Advisory Wire

REFERENCE NO: AW700-24-0598, Rev 14

SUBJECT: Variable Frequency Generator (VFG) GL511-1103-9 – Failure

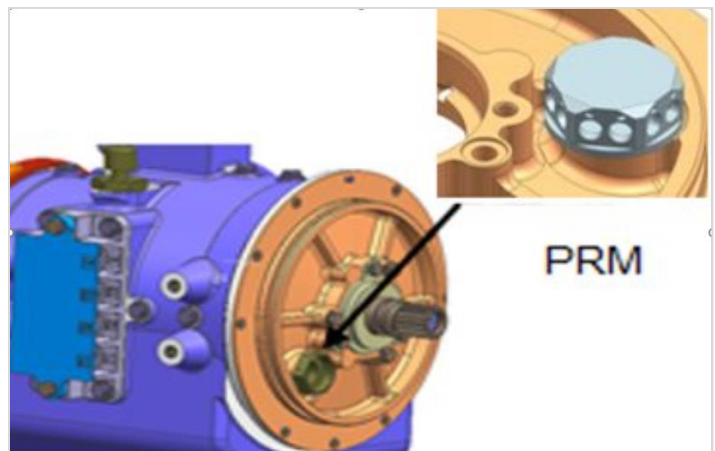
As a mitigation against VFG housing rupture, a PRM will be introduced to the VFG.

The PRM consists of a burst disc set to activate at a predetermined pressure. The PRM will vent the internal pressure of the VFG overboard via the dry drain mast using the existing drain system.

Bombardier is planning to release Service Bulletins (SB) that will provide instruction to remove the existing Thermal Dump Valve (TDV) of the VFG -9 and replace it with the PRM. The SB will also include instruction to re-identify the part number of the VFG to GL511-1103-11.
